2020/3937/P – Workshop R/O 38-52 Fortress Road, Fortress Grove, NW5 2HB

2020/3937/P – Workshop R/O 38-52 Fortess Road, Fortess Grove, NW5 2HB

Delegated Report (Members Briefing)		Analysis sheet	Expiry Date:	26/11/2020
		N/A	Consultation Expiry Date:	01/11/2020
Officer			Application Number(s)	
Ben Farrant			2020/3937/P	
Application Address			Drawing Numbers	
Workshop Rear of 38-52 Fortess Road Fortess Grove London NW5 2HB			Please refer to draft decision notice	
PO 3/4	Area Team Signature	C&UD	Authorised Officer Signature	
Proposal(s)				
Variation of condition 3 (approved plans) of planning permission ref: 2017/4731/P dated 31/10/2017 for 'Installation of replacement roof to workshop building, alterations to entrance and replacement fenestration', namely to: Increase the height of the roof ridge by circa 100mm and alter the proposed roof material.				
Recommendation(s):	Grant conditional planning permission			
Application Type:	Variation of condition

- 4) Proposed section, showing rooflight design as previously approved.

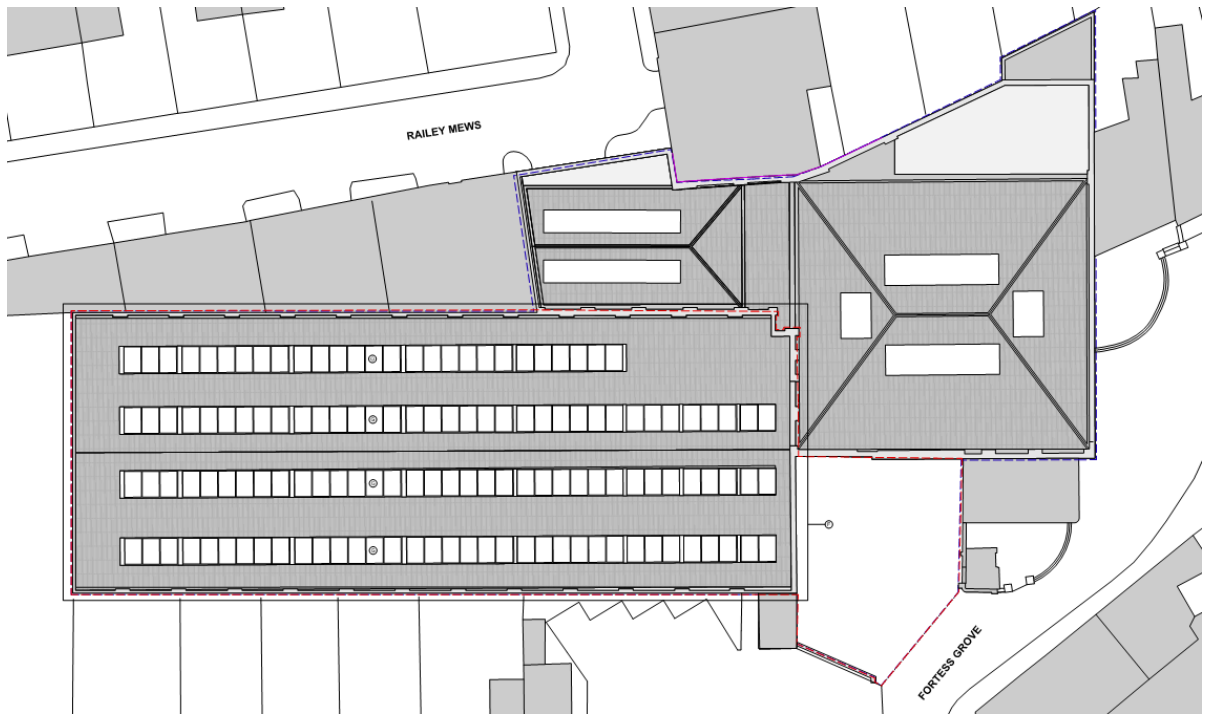
“Can you confirm the lower level east facing roof lights are no longer required: Drawing 1014-GS-01 proposed section 01 and 1014-PL-A-17 proposed east elevation (Railey mews)

Should it be proposed the lower east facing roof lights are to remain; the two drawings are misleading to say the least.

The rooflights would remain in the same location as previously approved, as shown on the proposed GA roof plan (bar the removal of a small section of rooflights on the Railey Mews facing portion of the roof, as shown on the attached photo sheet). The confusion appears to arise as the submitted section shows one rooflight facing Railey Mews, this is owing to the location of the section as shown on the key plan. There are two sets of rooflights further to the rear of the building as shown on the proposed GA roof plan.

5) Previously approved roof plan under ref: 2017/4731/P dated 31/10/2017.

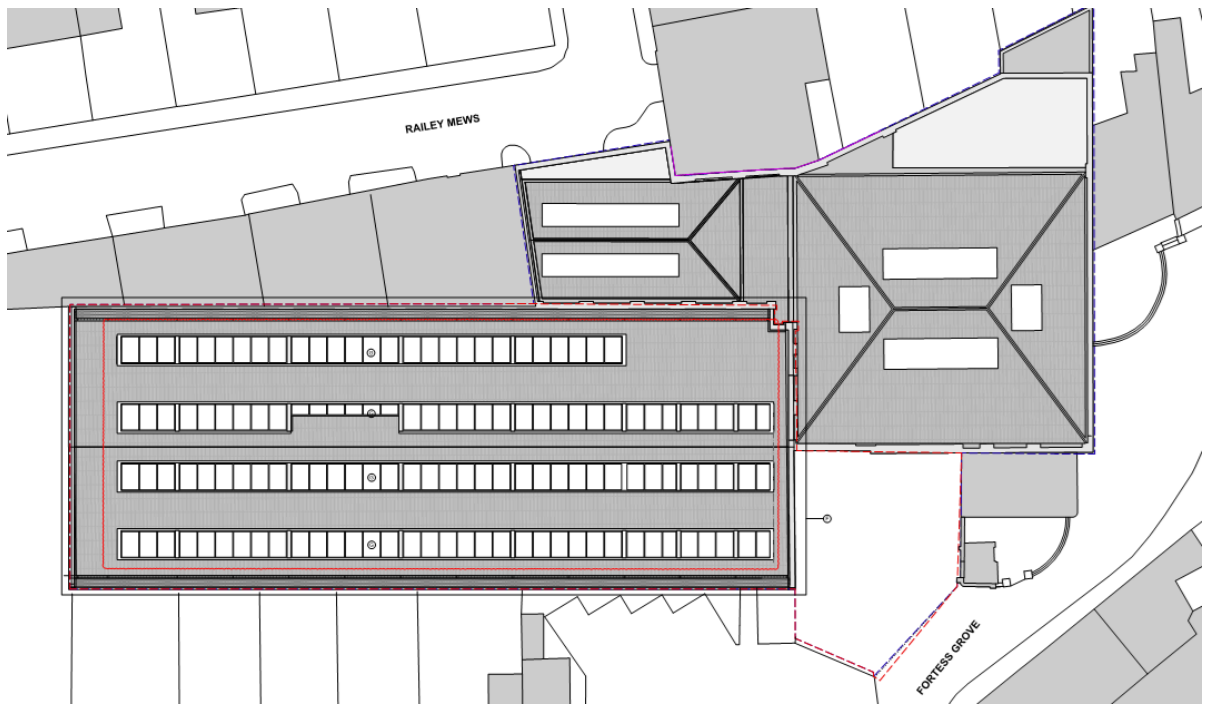
6) Proposed roof plan showing section of Railey Mews facing rooflights removed.
